SOUTHERN CALIFORNIA EDISON CIRCLE CITY SUBSTATION AND MIRA LOMA-JEFFERSON 66 KV SUBTRANSMISSION LINE PROJECT

Final Environmental Impact Report

December 2018

Figure 4.1-10 Visual Simulation

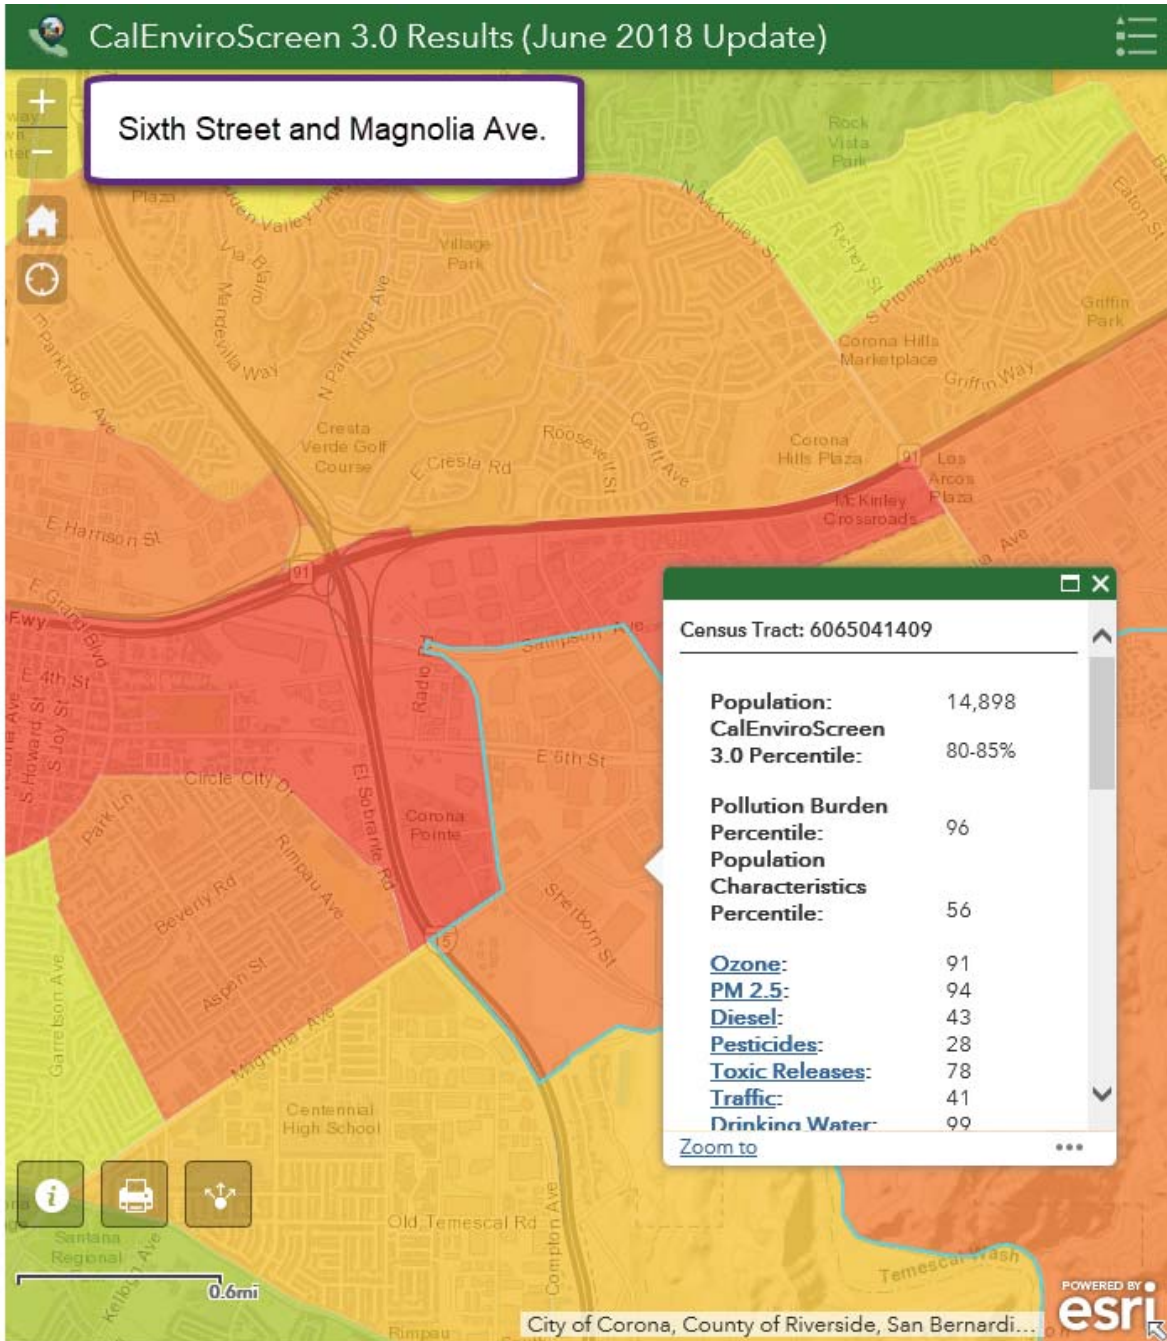
Second, the DEIR errs in concluding, *based on the simulation view provided in Figure 4.1-10*, that the new poles would only result in “relative minor” visual change to the area because “The lighter color and simpler form of the new poles would be less noticeable against the sky when compared with the existing reddish-brown colored poles” and because “the new poles more closely resemble the color of existing streetlights, resulting in a more unified streetscape.”²¹ The DEIR’s reliance on Figure 4.1-10 is particularly problematic. Figure 4.1-10 provides the current view from River Road Park:

This “visual simulation” (which was provided by SCE) is misleading. Although it appropriately demonstrates that the new poles would be *significantly* taller than existing poles, Figure 4.1-10 depicts the new poles as being a uniform light grey color that blends into the background sky, while failing to depict, among other things, the shadowing that makes the streetlight in the foreground of Figure 4.1-10 and the existing wood poles in the first photo of Figure 4.1-10 clearly stand out.

Images 3, 4, and 5 clearly demonstrate that the light grey color does not make LWS poles blend into the sky as depicted in Figure 4.1-10. Instead, despite their color, these poles are the *dominant visual features* of their areas, with the level of their visual dominance determined by pole height, and, to a lesser extent, the number of wires strung on the poles, not color. The flawed nature of the DEIR’s reliance on Figure 4.1-10 is most clearly demonstrated by a simple side-by-side comparison of the “visual simulation” and Image 5, a real-world photograph of similar LWS poles. This comparison is provided as Exhibit E.

The DEIR should be modified to eliminate all reliance on Figure 4.1-10, particularly the claim that due to the color of the poles the “visual change from this location would be relatively minor.”²² Instead, the DEIR should recognize that the color of the pole is of minimal relevance, and that the determining factor for visual change is pole height. Given the substantial increase in pole height (as demonstrated in Figure 4.1-10) the visual change from River Road should be changed from “Low to Moderate” to “Moderate to High,” and the visual change from River Road Park and other affected sites (including the Schools and YMCA) should be changed to “High.” In order to prevent these permanent, significant aesthetic impacts to the River Road area, the Alternative C1 should be amended eliminate the existing overhead lines and poles and

The visual simulation shown in Draft EIR Figure 4.1-10 was chosen because it depicts the proposed Project from an outdoor public park and would be directly visible from users of the park (River Road Park). The KOP in this figure is intended to be representative of views of the proposed Project in the area of River Road. The comment is correct that the proposed Project would also be visible from the schools and YMCA located further down River Road. However, all three facilities are within 0.5-mile of the KOP depicted in Figure 4.1-10. The visual sensitivity of viewers from these facilities would be similar to those from River Road Park (moderate to high) and the overall visual change would also be similar (low to moderate). Therefore, since the visual impact would be similar to that shown in Figure 4.1-10 for these locations, resulting in a less-than-significant impact, the CPUC disagrees with the City that the aesthetic impact analysis determination associated with the Project along River Road is in error.

- A16-26 The CPUC disagrees that the visual simulation in Draft EIR Figure 4.1-10 is misleading. Due to the location of both the existing poles and proposed poles relative to the angle of the sun when the existing photograph was taken, as shown in Draft EIR Figure 4.1-10, shadows from the existing and proposed poles fall to the right of the pole locations (i.e. away from the street) and would not be prominently visible from the photo viewpoint due to the wall and fencing on the east side of River Road. However, because the color of the existing streetlight and proposed poles are similar, the shadowing to the right of those structures is also similar. The existing wood poles are shown with greater contrast to the blue sky due to their darker color. Shadows do not play a predominant role in this visual character analysis because (1) shadows are currently associated with the existing poles (the increased height would only slightly affect the duration of a shadow), (2) shadows typically do not play a large role in a visual character analysis. This is also generally consistent with the City of Corona’s own EIR aesthetic analyses.

- A16-30 As noted in the fourth paragraph of the *Mira Loma-Jefferson 66 kV Subtransmission Line* discussion in Draft EIR aesthetics Impact 4.1-3, the proposed poles shown in Figure 4.1-10 “would be less noticeable against the sky when compared with the existing reddish-brown colored poles.” While the new proposed poles would be taller than the existing poles, the new poles would carry the same number of lines as the existing poles. Same as the existing poles, the new poles would include a double-circuit configuration with underbuilt distribution and telephone lines. The level of visual change attributable to the proposed Project along River Road is more appropriately shown by a direct comparison of the existing lines with the simulation of the proposed lines, as provided in Figure 4.1-10, rather than a comparison to a photograph of a different line segment along Railroad Avenue under different lighting conditions and from a different viewing angle.

FIGURE 3-2B

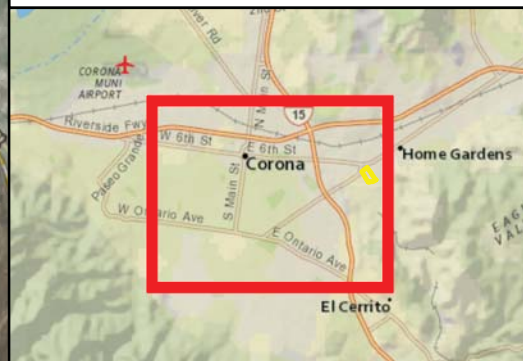
Section	Page	DEIR Language	SCE Recommended Language	Reason for Change in DEIR	
Figure 3-2b	3-15	The figure does not show the required telecom routes for this alternative.	Please revise to include the telecom routes shown on <u>Attachment 2</u> hereto.	Proposed edits are intended for clarity as the figure does not show the required telecom routes for this alternative.	A20-83

- A20-83 Draft EIR project alternatives Figure 3-2b has been updated to identify the existing and new fiber alignments that would be used/constructed under Alternative C3 to connect the 40 MW battery storage facility to SCE's telecommunications system consistent with Attachment 2 of SCE's comment letter. Refer to the revisions to *Chapter 3, Project Alternatives*, in Final EIR Chapter 4, *Revisions to the Draft EIR*, for the updated Figure 3-2b.

- A20-94 Draft EIR Figure 3-2b has been revised to reflect SCE's revised description of the required telecommunication facilities for Alternative D1. Refer to the revisions to *Chapter 3, Project Alternatives*, in Final EIR Chapter 4, *Revisions to the Draft EIR*, for revised Figure 3-2b.

Figure 3-3
Alternative D1: 12 kV Distribution-Level Battery Storage Conceptual Layout

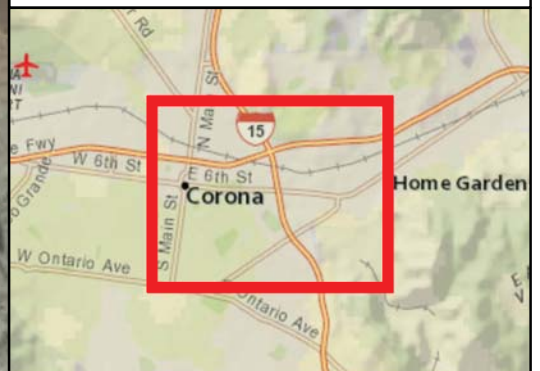
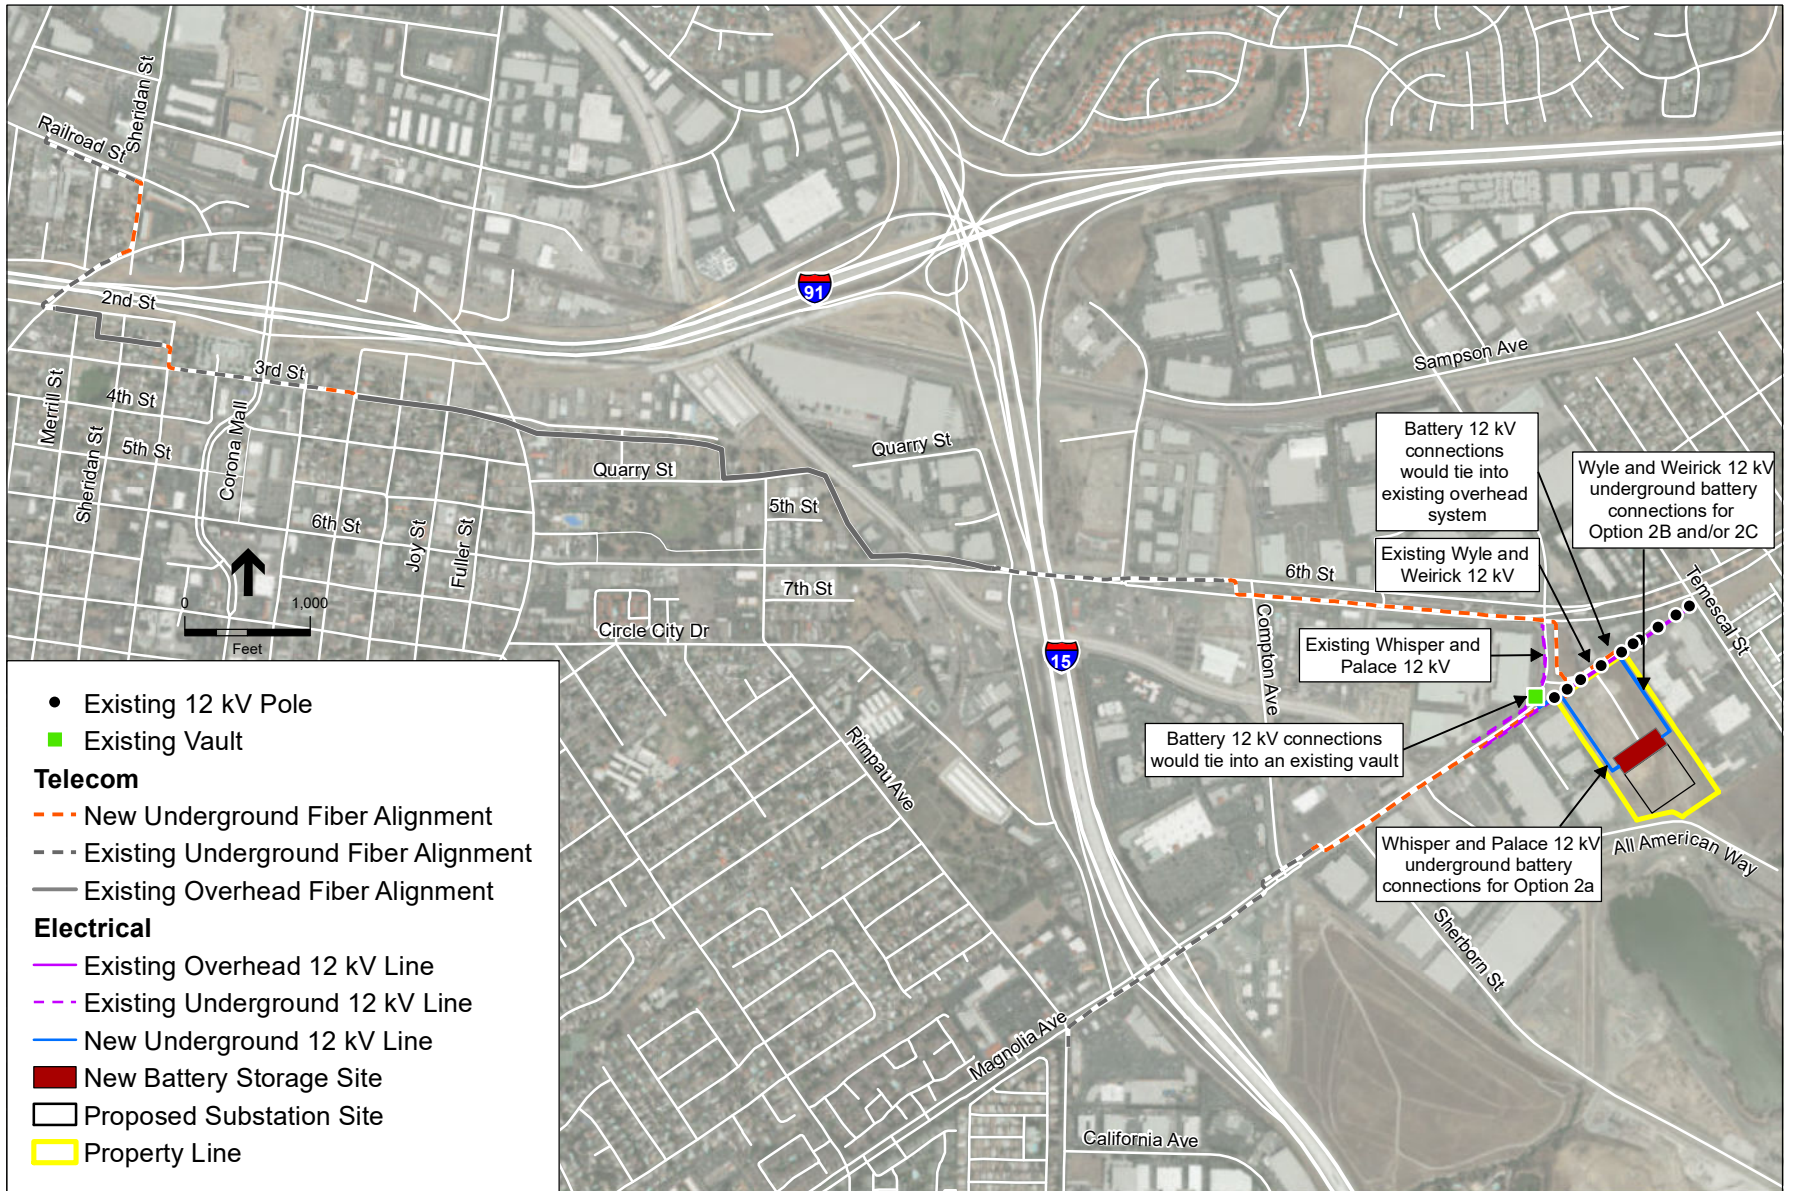
Section	Page	DEIR Language	SCE Recommended Language	Reason for Change in DEIR
			<u>[Footnote text:] "Installation of phase 1 for operation by 2021 would allow SCE to operate the battery storage installation for several years in advance of the projected capacity shortfall in 2024. This would provide SCE the opportunity to gain operational experience with the battery installation and to evaluate its performance under a variety of system conditions prior to the anticipated capacity shortfall addressed by the batteries."</u>	
Figure 3-3	3-22	The figure does not show the second telecom route required for this alternative.	Please revise the figure to show the second telecom route as shown on <u>Attachment 3</u> .	Proposed edits are intended for technical accuracy as a second telecommunications line (in addition to the Magnolia route depicted) would be required to connect the facility to SCE existing telecommunications system. <u>Attachment 3</u> hereto includes a map of the telecommunications route.

A20-91 Draft EIR Figure 3-3 has been updated to identify the second telecommunications route, with existing and new fiber alignments, that would be used/constructed under Alternative D1 consistent with Attachment 2 to the SCE's comment letter. Refer to the revisions to *Chapter 3, Project Alternatives*, in Final EIR Chapter 4, *Revisions to the Draft EIR*, for the updated Figure 3-3.

Draft EIR Figure 3-3 has been updated as shown on the following page to identify the second telecommunication alignment for Alternative D1.
